WATER AND WASTEWATER SERVICES REPORT

Ryans Road Industrial Development

Report To (Planner):	Francis White	Address:	104 Ryans Road
Report To (Engineering):		Applicant:	Carter Group Limited
Date:	08/07/2025	Consultant:	Pattle Delamore Partners
Council Nr.:	RMA/2025/1208	Author:	Michele McDonald
Record File Nr.:		Team Leader:	Michele McDonald
Zoning	Industrial	# lots	126 lots (55.5 hectares)
Legal Description

Figure 3.1 – Northwest future water demand projections including 104 Ryans Road

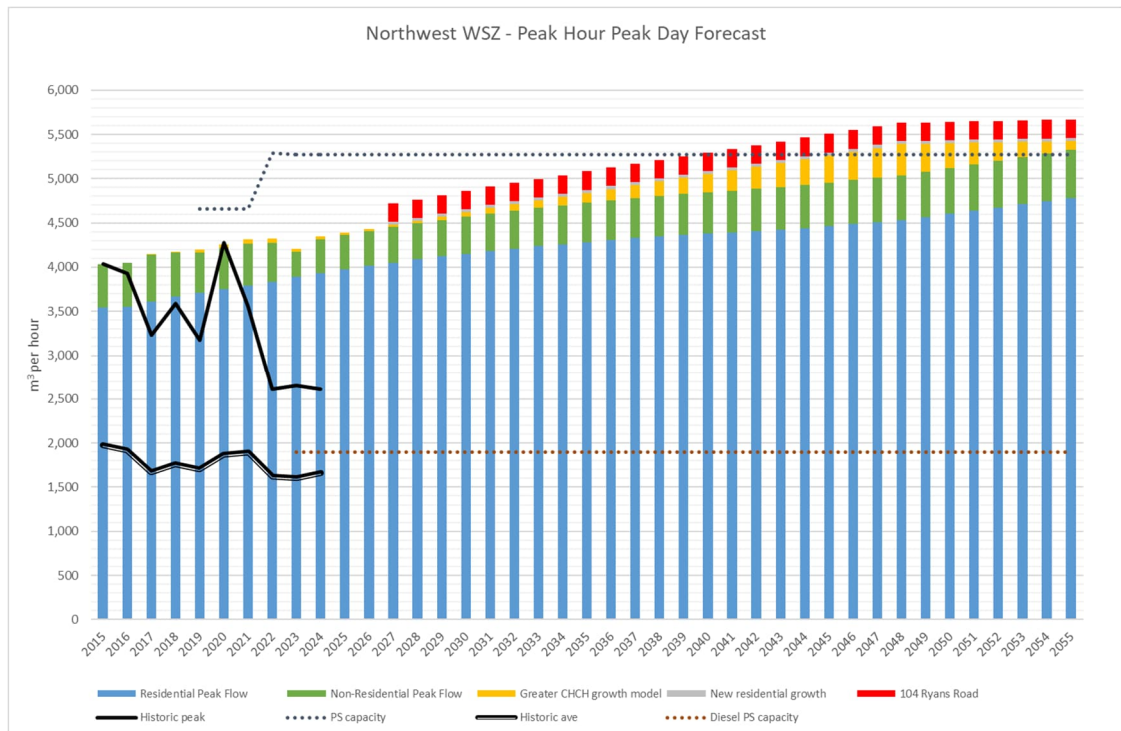
- 3.10 **Figure 3.1** below shows that the development will accelerate the need for additional water supply capacity by approximately five years. However, if the Council can maintain the water demand reductions achieved through excess water use charges, there will be sufficient capacity to meet the future projected demand as well as the additional demand introduced by this development. It should however be highlighted that the future growth projected in Figure 3.1 does not align with medium density residential standards nor does it account for additional greenfield development.

Figure 3.2 – Impact of development on the capacity of the immediate water source (no growth)

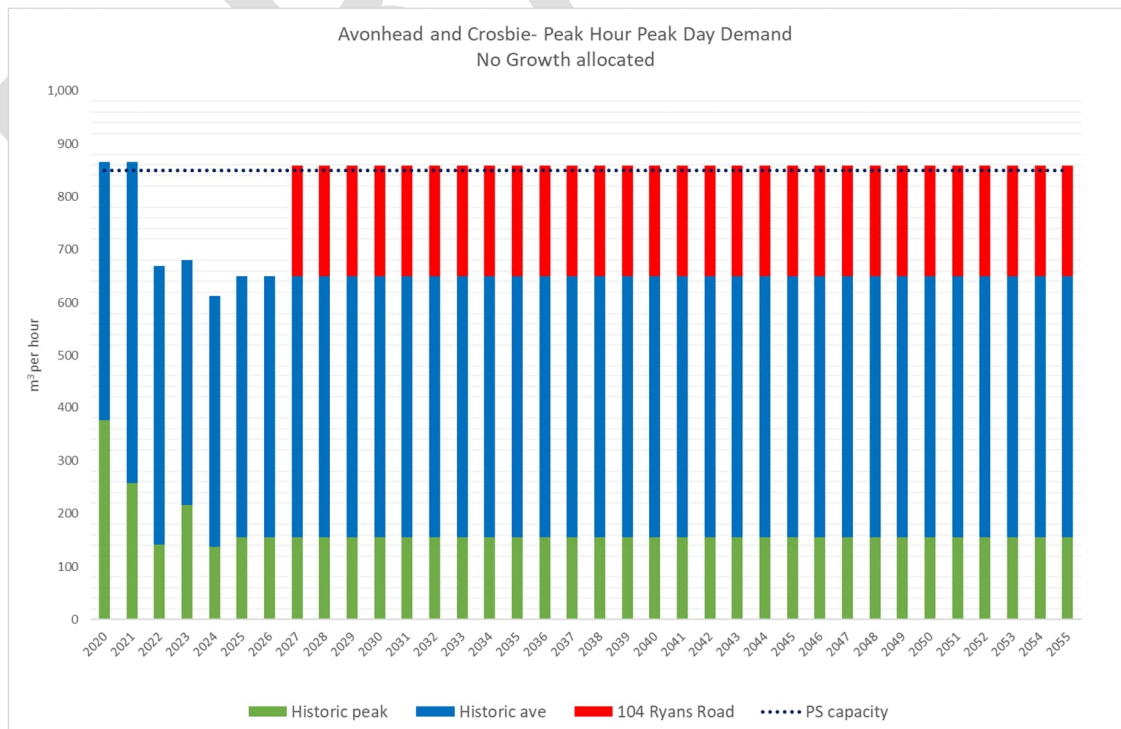
3.11 As illustrated in Figure 3.2, the development's impact on the primary water source and the adjacent pump station is a concern. If the development's peak water demand should coincide with the existing peak demand on these pump stations, there will be no surplus capacity to accommodate future growth. This is corroborated by the water model, which indicates that meeting the development's peak water demand will require activating additional wells and pumps at both the Crosbie and Burnside pump stations.

Figure 3.3 – Impact of development on the capacity of the immediate water source (alternative peak, no growth)

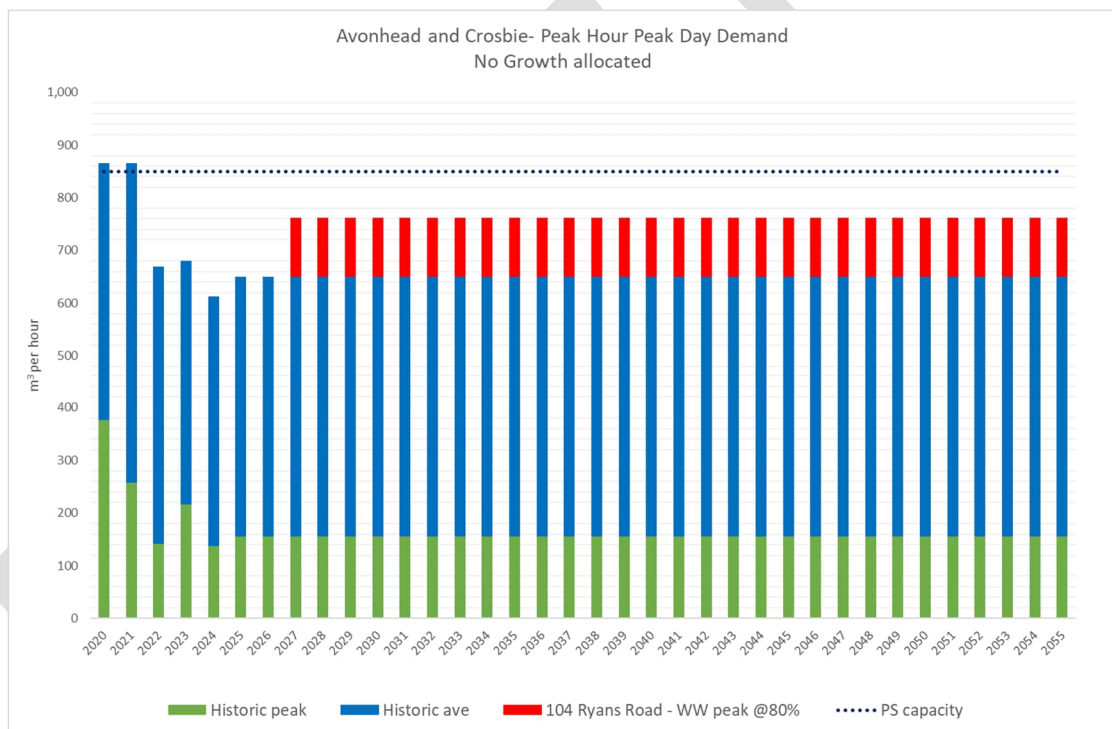
- 3.13 **Figure 3.3** presents the peak demand as calculated by the above methodology and which confirms that by limiting the wastewater discharge allowance of each lot, a residual water supply capacity will be available to service an additional 750 to 1,200 residential units, depending on whether the reduced water demand achieved through excess water use charges, can be retained. This aligns with growth projections for the surrounding area but does not cater for intensification aligned to Medium Density Residential Standards.
